Construction Division
Additions & Alteration Charges Approval Form

GULMOHAR RESIDENCY

Details of Additions & Alterations

Flat No	401	Block no.	' D '
Flat Area	1660 sft	Type	Deluxe / Luxury
Buyer Name	Sunil Kumar		
Phone No.	9959060067	Email	SunilKumar1975@gmail.com

ELECTRICAL PLAN -B2 TYPE-1660 sq ft

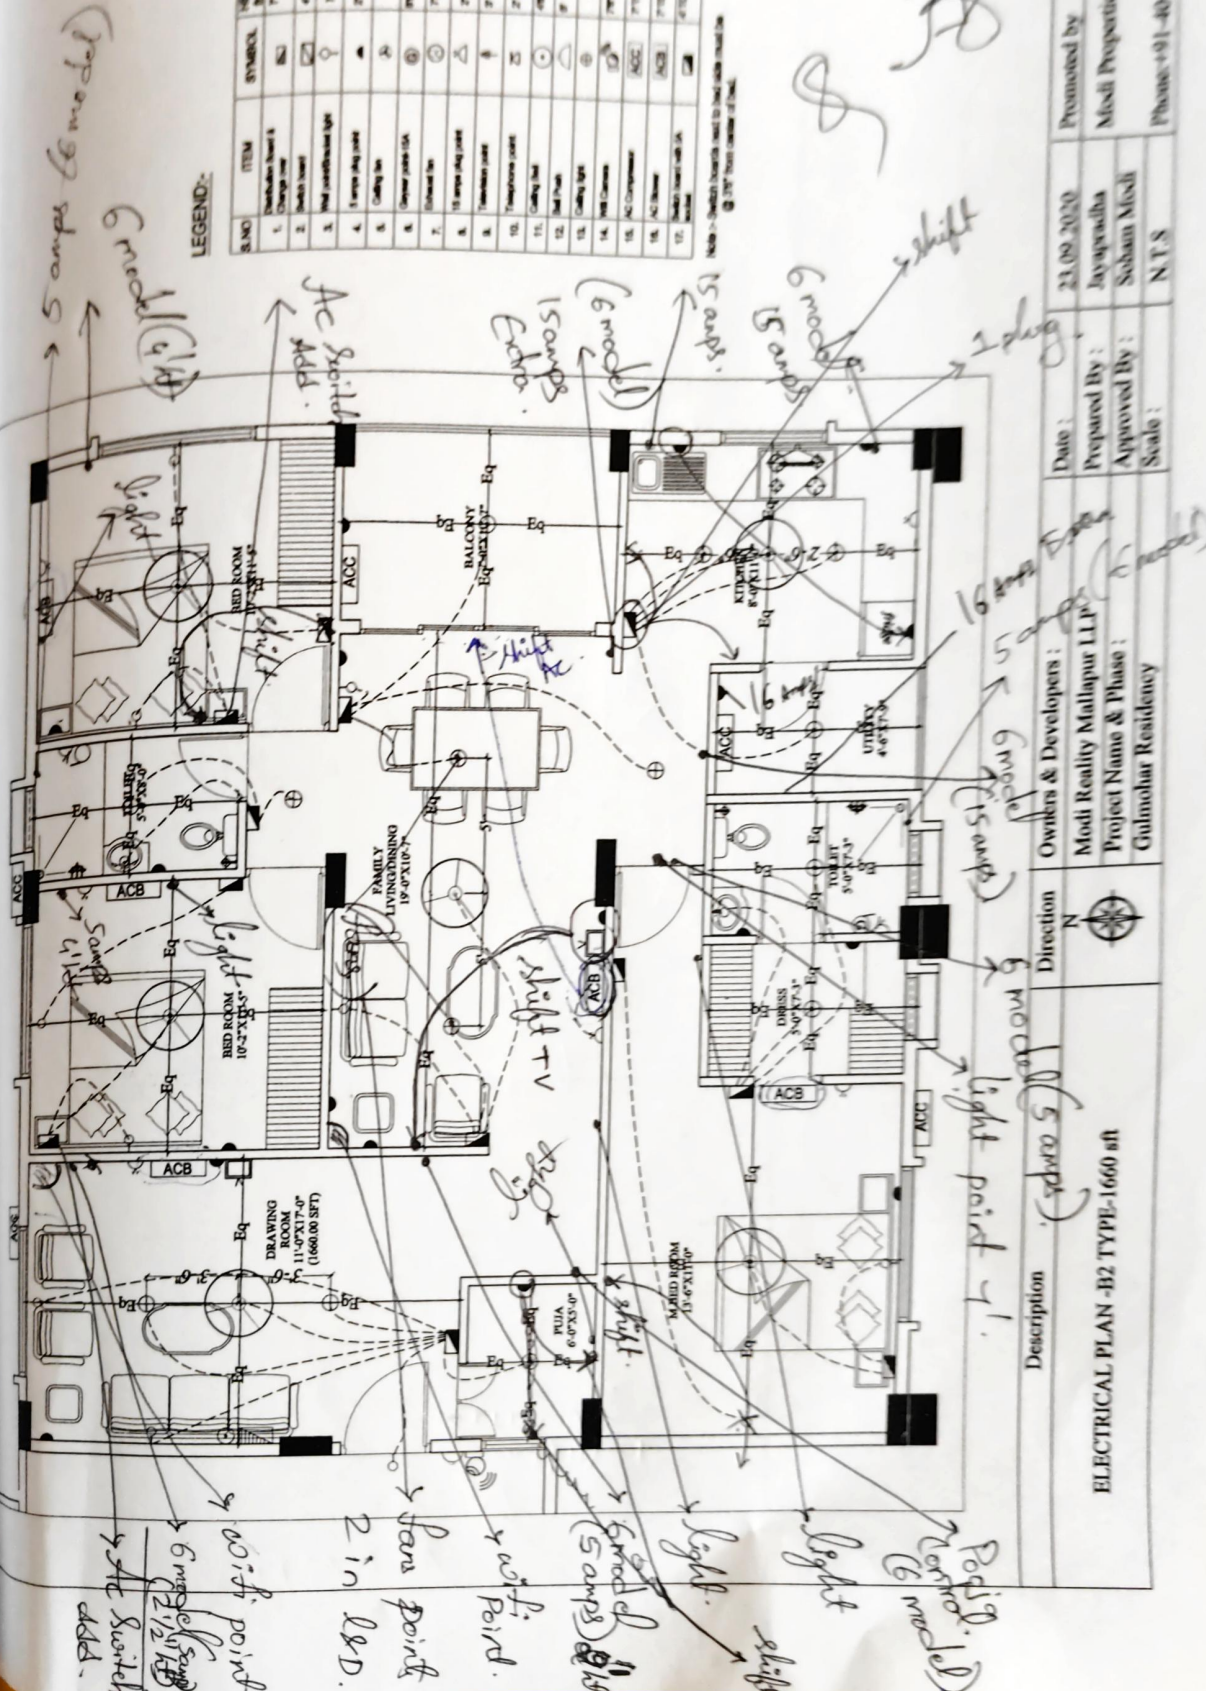
Changes in electrical points: (mark on plan)

- ① Electrical points to be changed & Add the points as per plan.
- ② patti on plat-brm.
